San Juan Police Building Expansion

Addendum NO. 02

CSP No. 25-004-3-13

Date: 03/11/2025

WATER TOWER

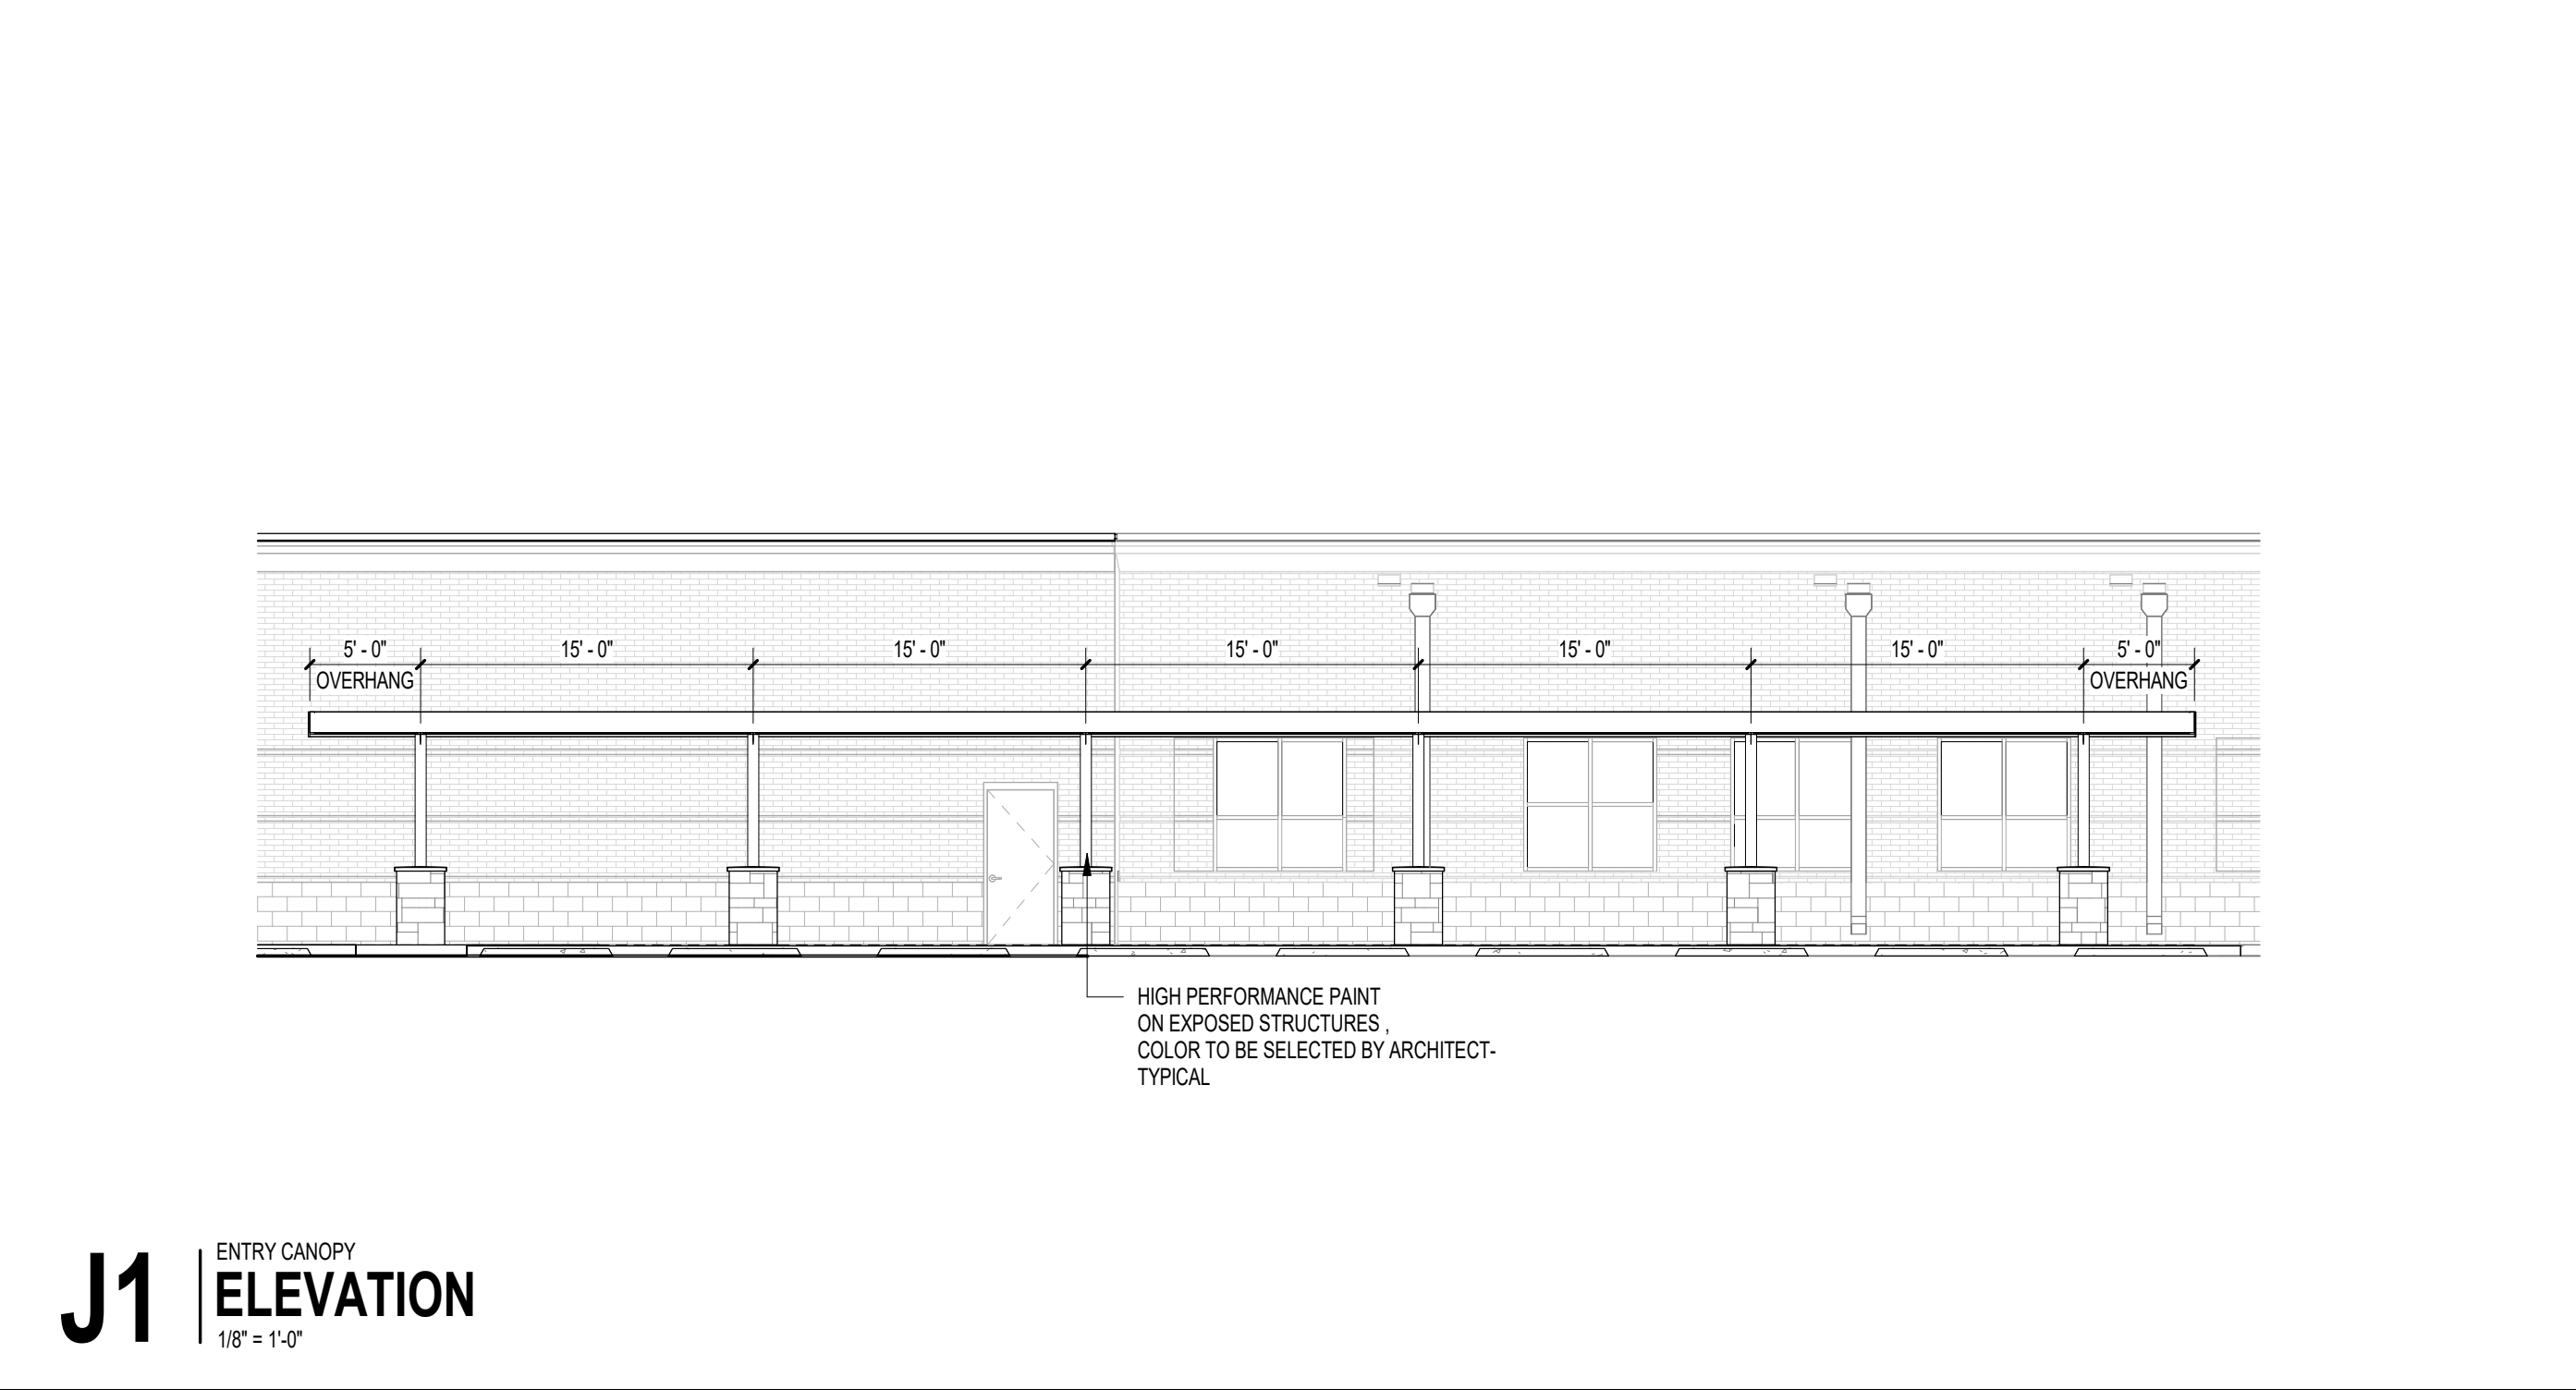
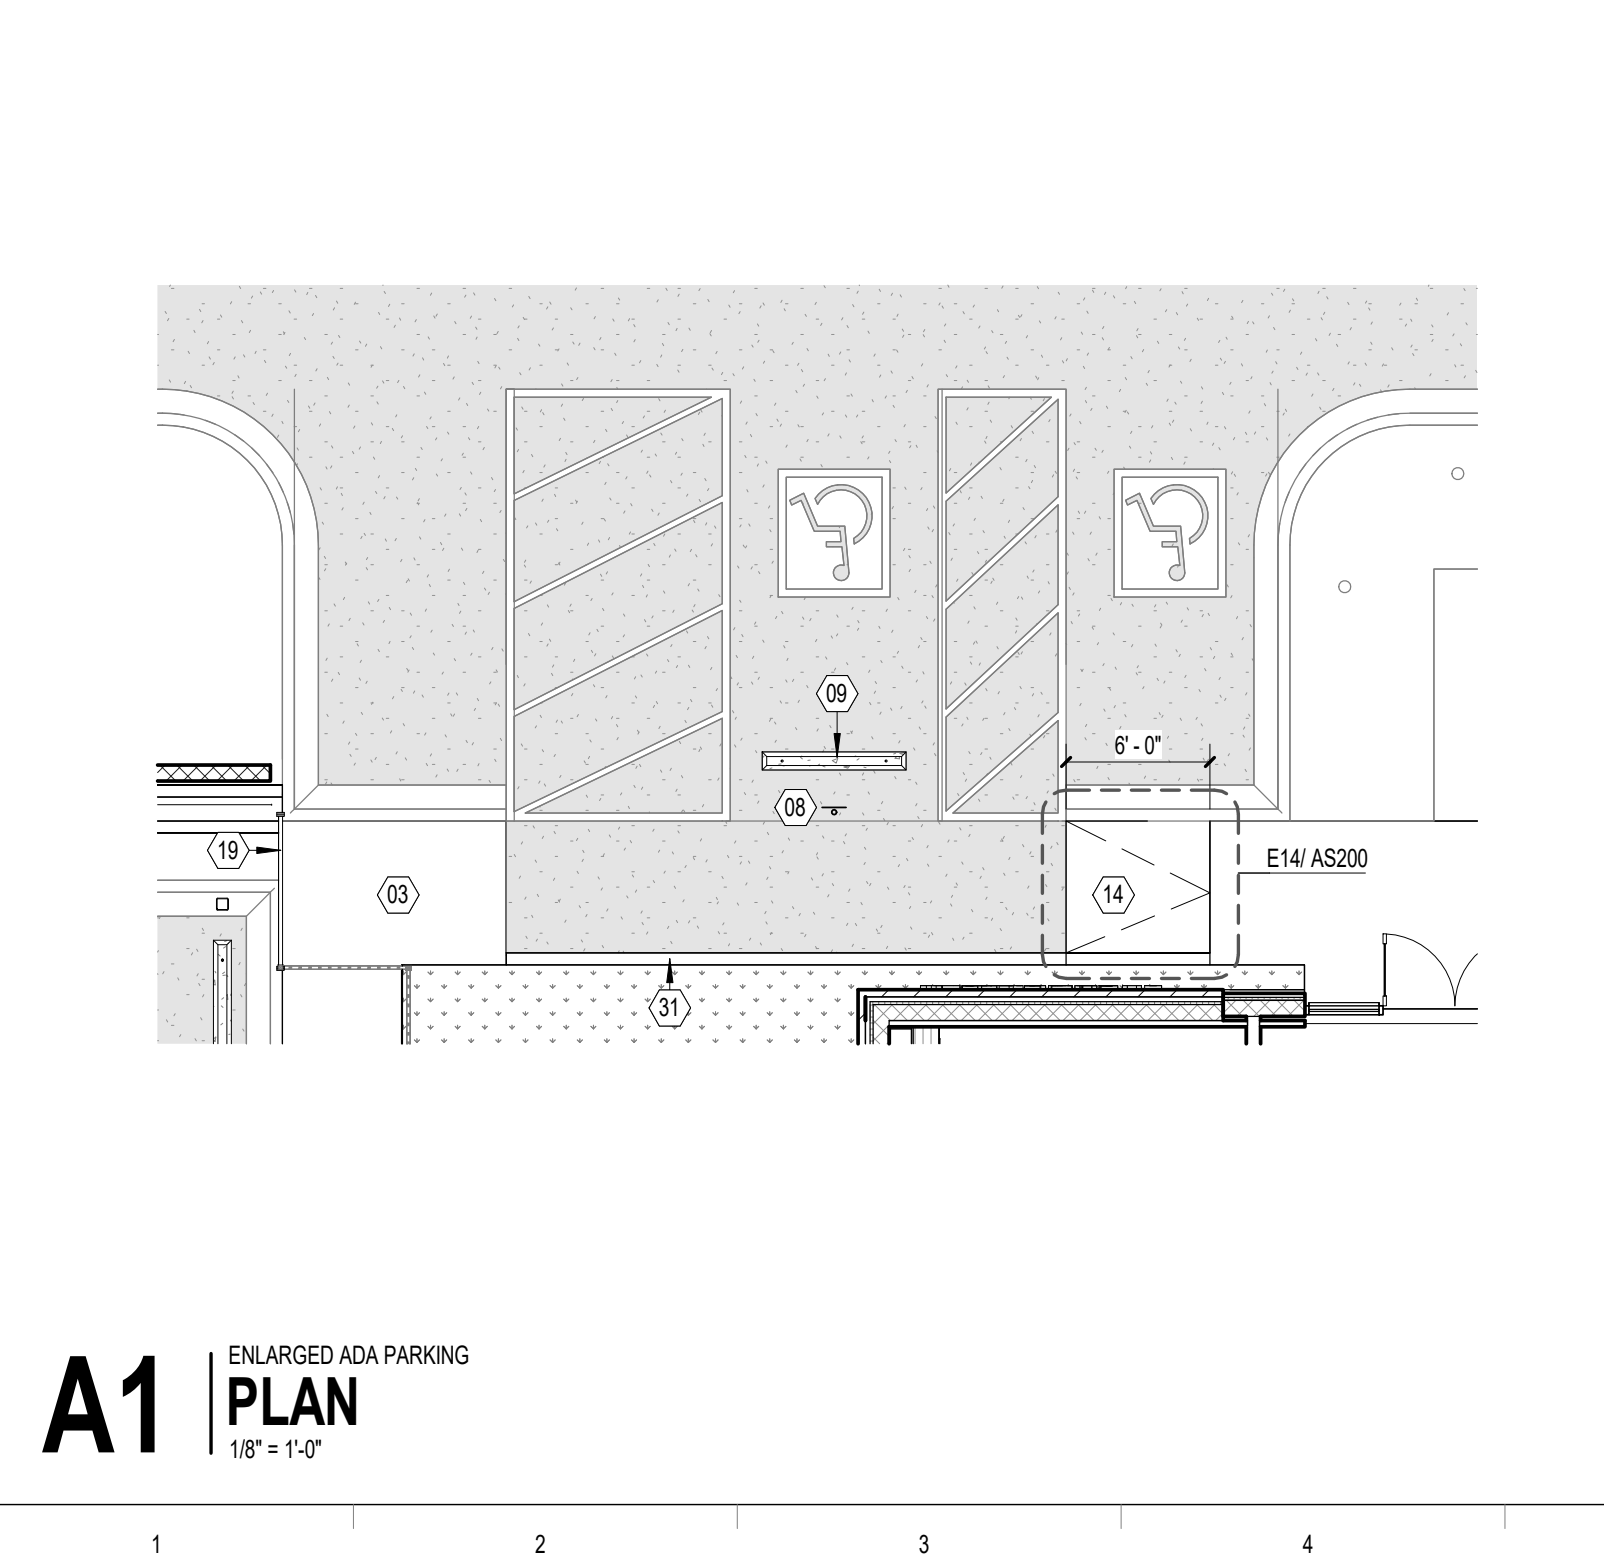
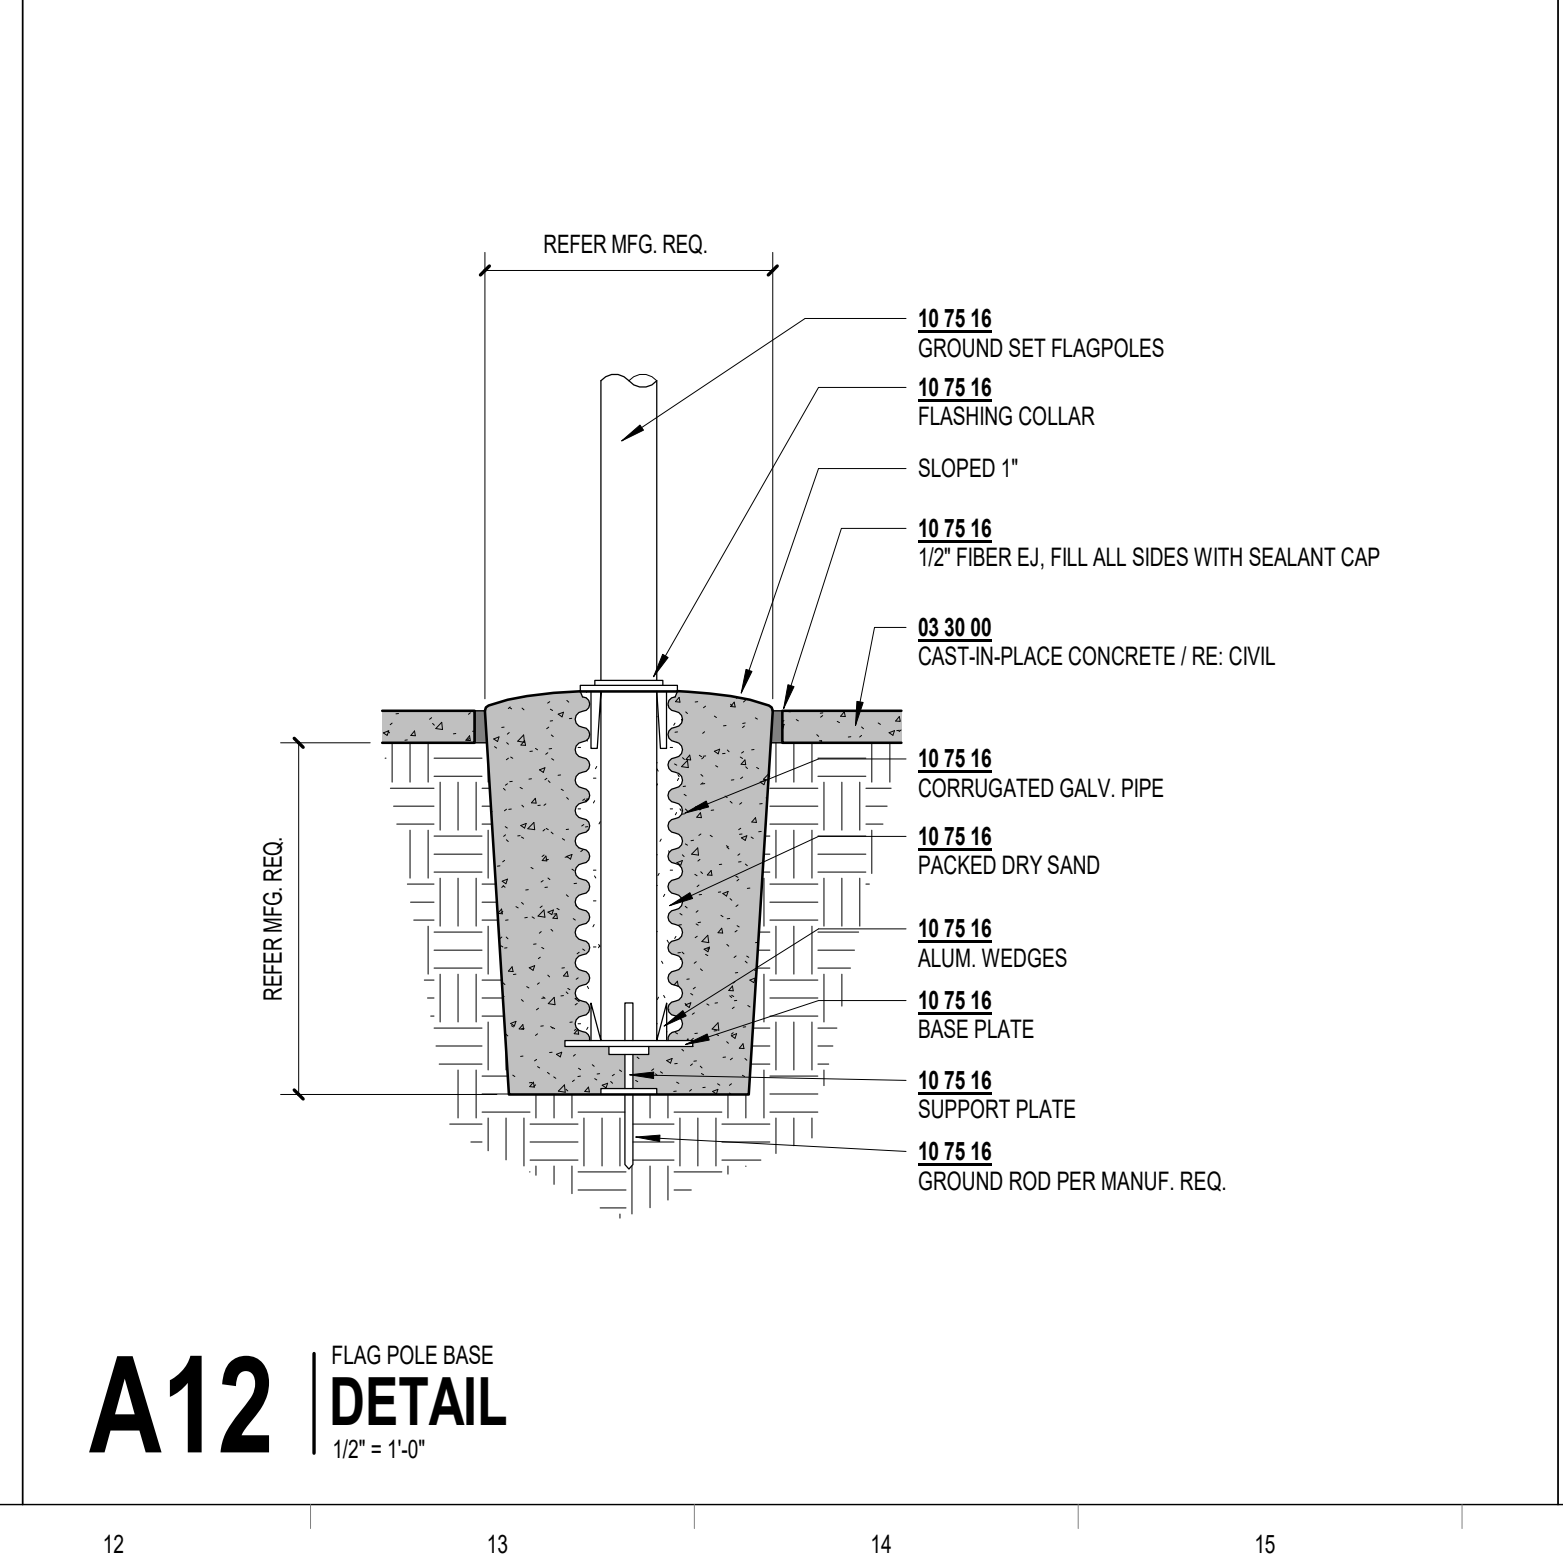
Sheet AS102 – ENLARGED SITE PLANS, Delete Sheet AS102 in its entirety.

Replace with revised SheetAS102 (refer to attached).
